5TH & VIRGINIA
DOUGLASTON DEVELOPMENT

FIRST EARLY DESIGN GUIDANCE July 7, 2015

OVERVIEW OF DESIGN RESPONSE

Preferred massing at EDG #1 looking south on 5th Ave

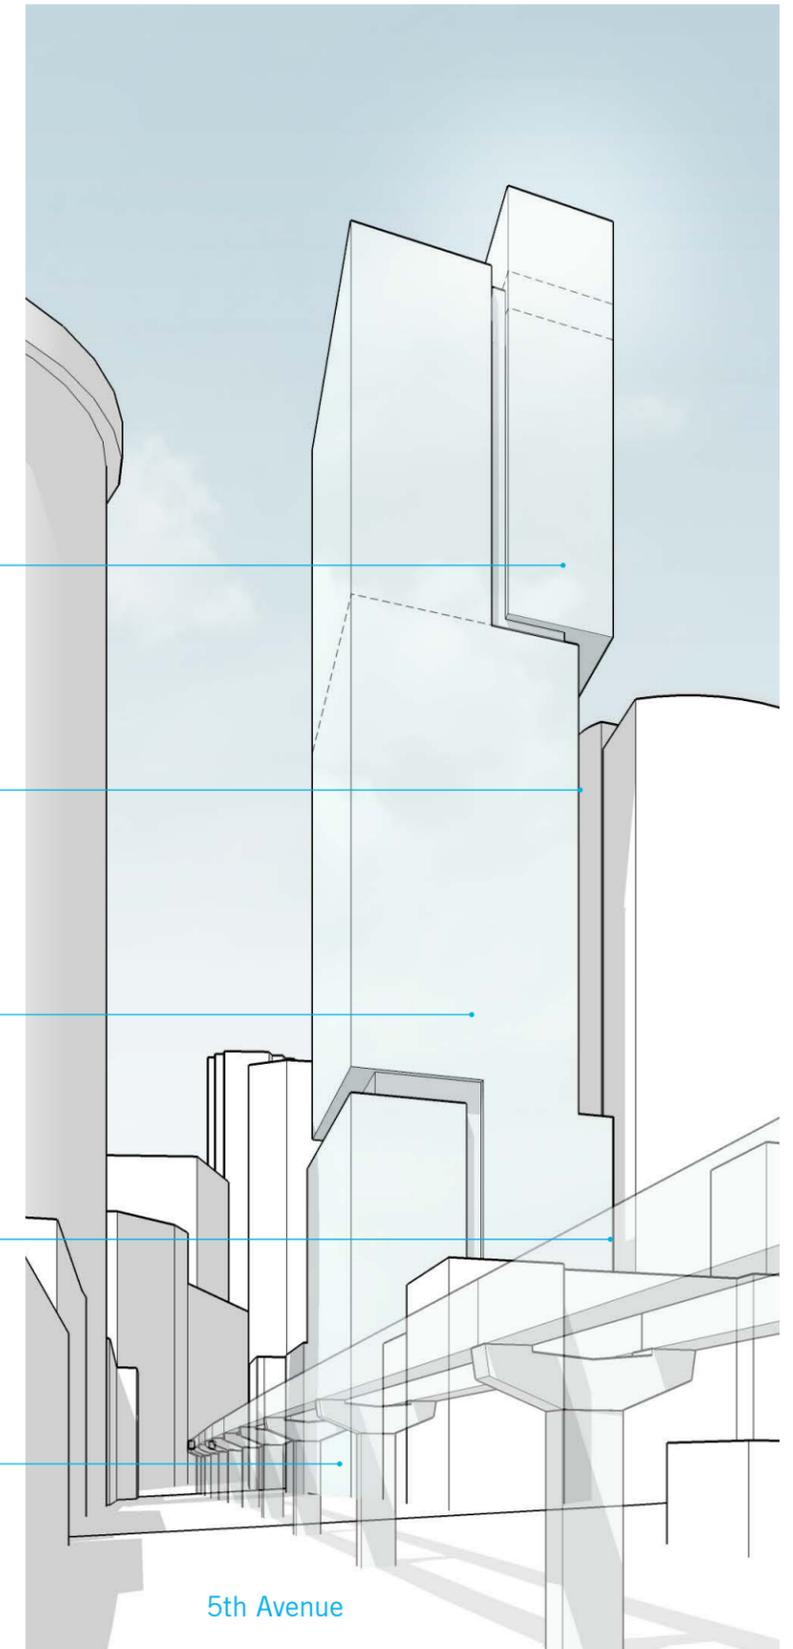
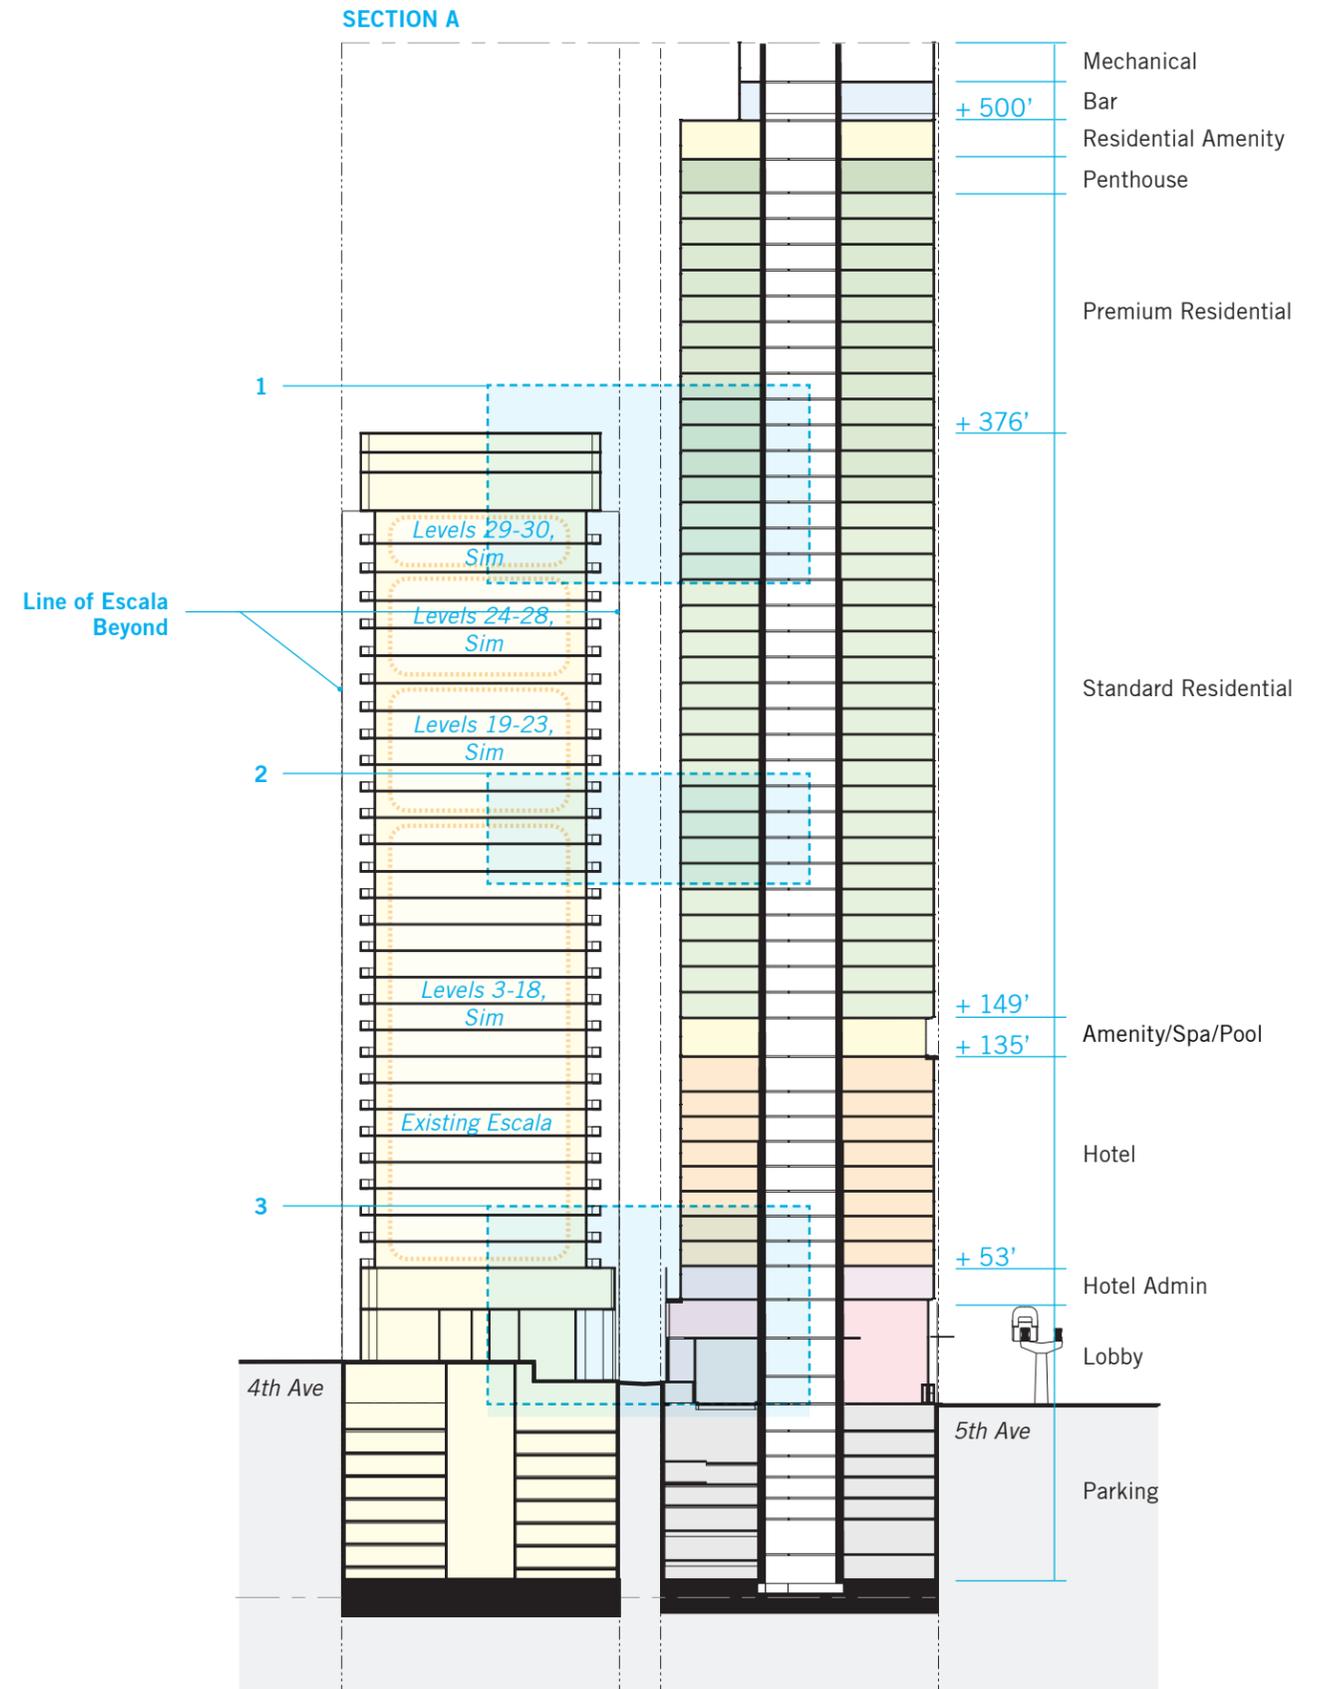
“The board recommended study of ‘the jewel’ element being shifted eastward to be in plane, or shifted to the east street side of the tower.”

“The board agreed that further studies that shape the alley façade of the proposed tower should be explored.”

The top 'jewel' element is now shifted and in plane without a cantilever...

The alley façade has been shaped with substantial north/south setbacks to open the tower corners...

PLAN, SPA AND POOL (FLOOR 12)

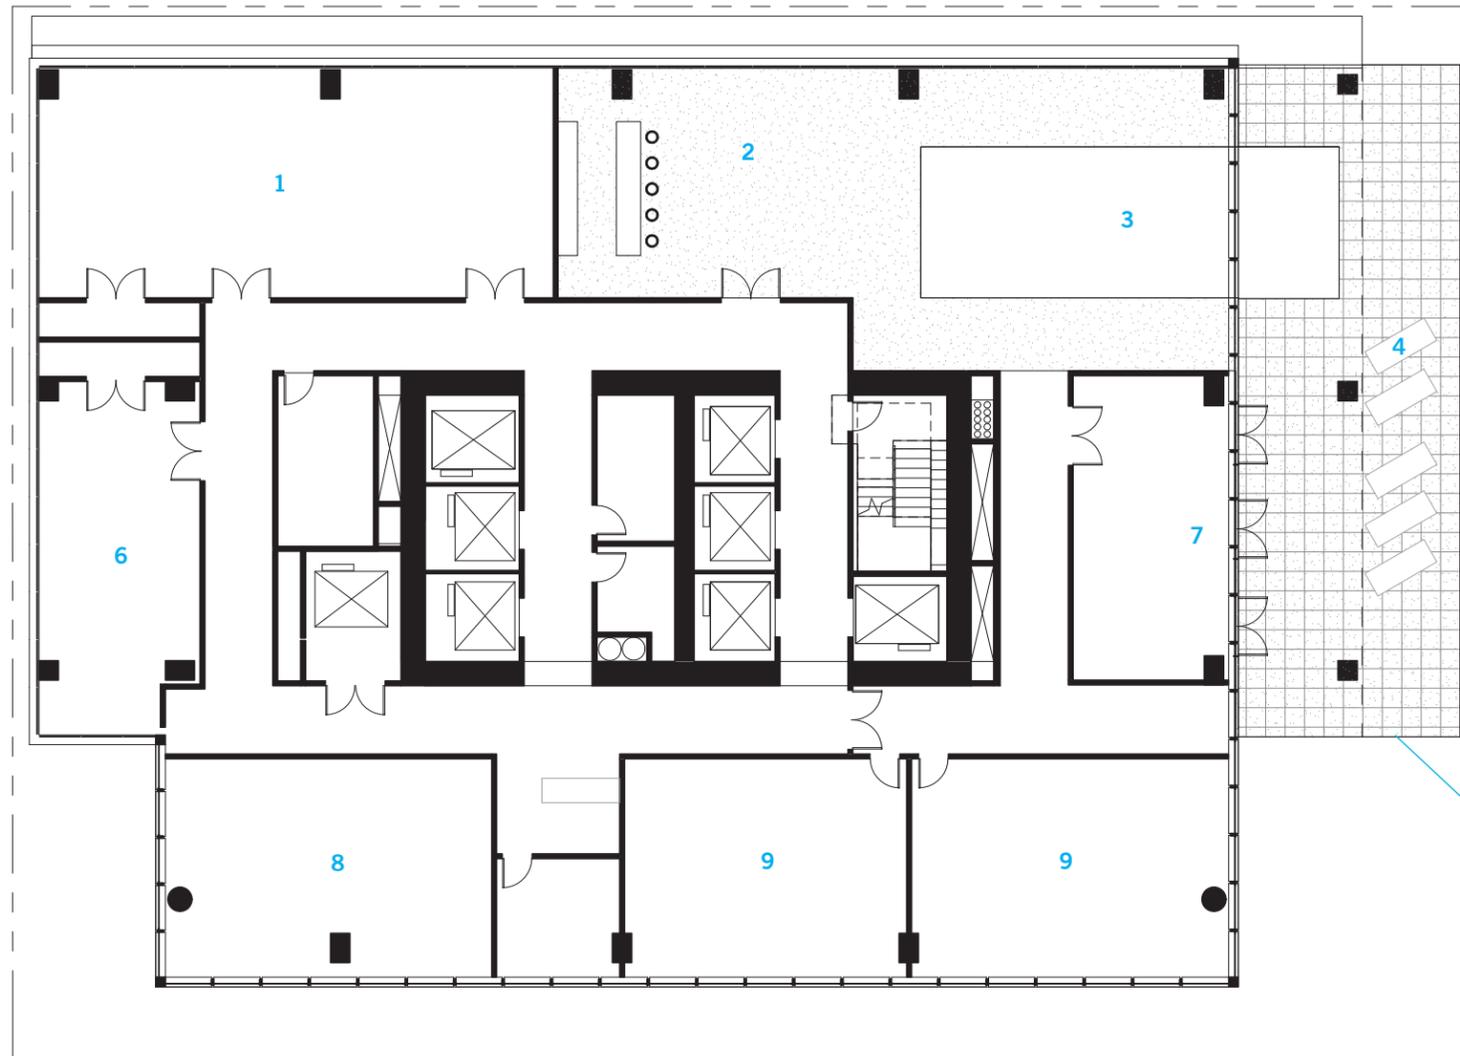
46	k) Complete floor plan of the amenity level 13, including the landscape design of any outdoor decks and details about privacy screening to the neighboring Escala.	A floor plan has been provided showing shared amenity level. The design team envisions screening along west and south portion of the exterior terrace.
54, 55	l) Detailed elevations and accurate renderings of all podium materials should be provided at subsequent meetings.	The design team has provided some possible materials under consideration. Additional material studies will be provided during the DRB meeting.
42, 59, 60	m) Replace the Virginia blank wall with an activating use or at minimum add a layer for display windows or a similar treatment that provides pedestrian scale and interest.	The design team has reconfigured the back of house to provide more activation along Virginia Street. The trash room and loading lock have been revised to allow for windows on Virginia Street.

- b. **Amenity Floor(s):** The Board supported the basic vertical stacking shown on page 40, but required a complete floor plan of the amenity level 13, including the landscape design of any outdoor decks and details about privacy screening to the neighboring Escala. (D1)

- 1 Fitness
- 2 Bar
- 3 Pool
- 4 Screened Outdoor Terrace
- 5 8' High Privacy Screen Wall
- 6 Yoga
- 7 Spa
- 8 Storage
- 9 Locker Rooms
